Subject: LADWP BRRTP Crossing #31-4 to 31-5 (105th St West x Astoria, Kern)
Barren Ridge S.S. to Haskell S.S. T.L. R/W
Antelope-Windhub 500kV T/L
APN 359-052-05
SCE File No. CON203051435

Southern California Edison Company (SCE), has reviewed and approved your request for Department of Water and Power, City of Los Angeles (LADWP) crossing the SCE Transmission Line shown on the attached plans entitled "Crossing at Southern California Edison Span 31-4 to 31-5, Drawing Number L83-SCE-31-4, sheet 1 of 1, dated June 19, 2015, date stamped approved by RP on August 21, 2015.

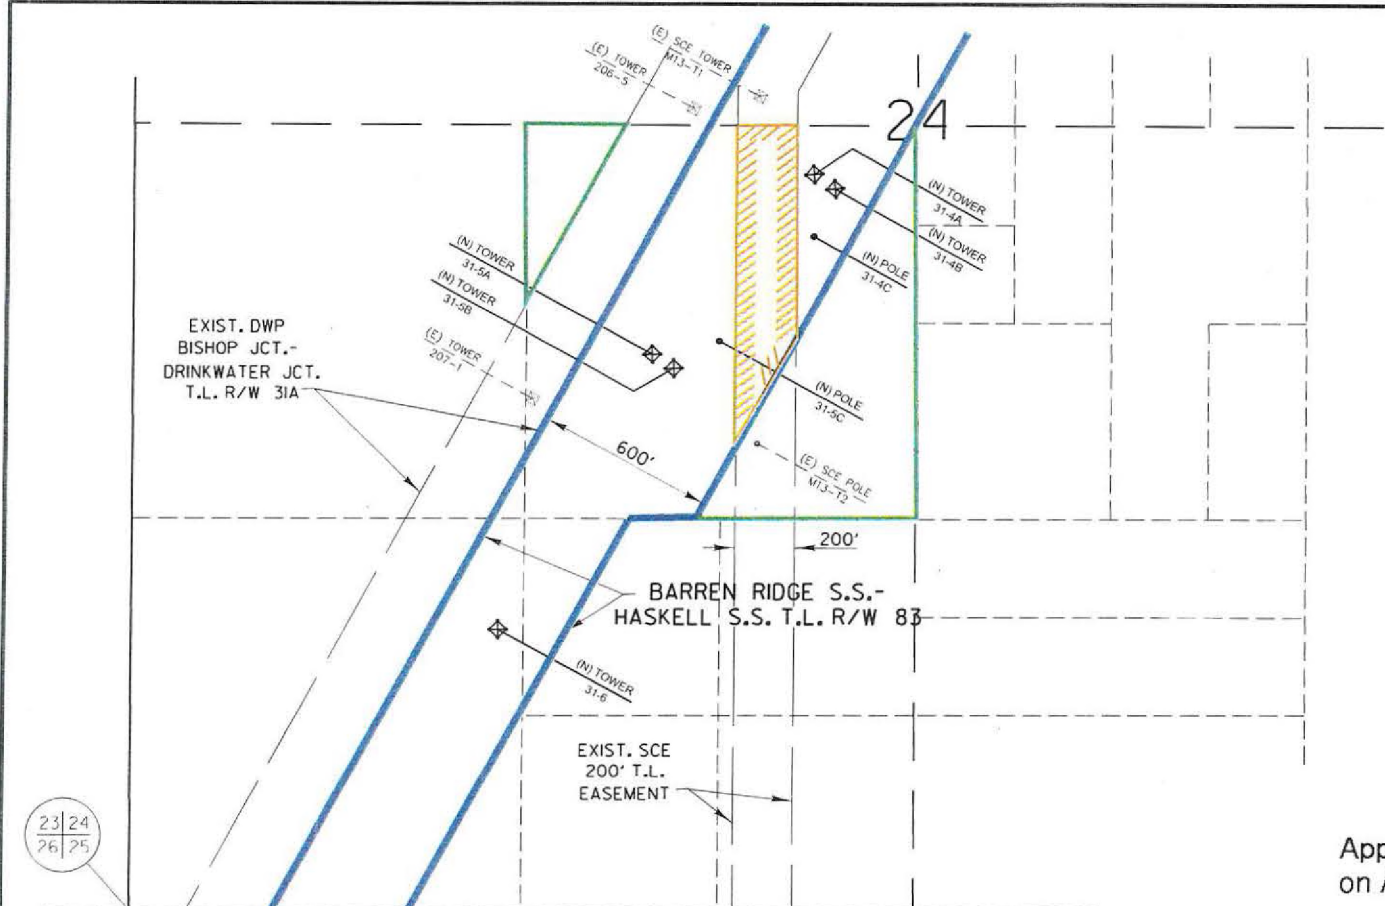
1. Adequate access to all structures must be provided and at no time is there to be any interference with the free movement of SCE's equipment and materials. (See Addendum 1 Table 1 - Standard Clearances)

2. At no time shall access to any SCE's facility be cut off or impeded in any way during any temporary grading operation.
3. All equipment working on the right of way must maintain a minimum clearance of 25-feet from all SCE structures in conjunction with the minimum clearances set forth in the California Code of Regulations, Title 8 Section 2946, Article 37 "Provisions for Preventing Accidents Due to Proximity to Overhead Lines" The minimum required equipment clearances also include SCE's Operating Conditions in which a minimum distance shall be maintained from all overhead conductors. (See Addendum 2 Table 2) If this minimum clearance cannot be maintained for any reason, LADWP will notify SCE and SCE may (at their own discretion), order an outage at the sole expense of the LADWP.

33. All tower and steel pole foundation projections are to be maintained between one and two feet above finished grade.
 34. Under no circumstances shall SCE's right of way be used or dedicated by LADWP for any environmental mitigation efforts. Any water quality measures, such as bio-retention, bio-swales, or other water quality features requiring maintenance shall not be allowed on the right of way.
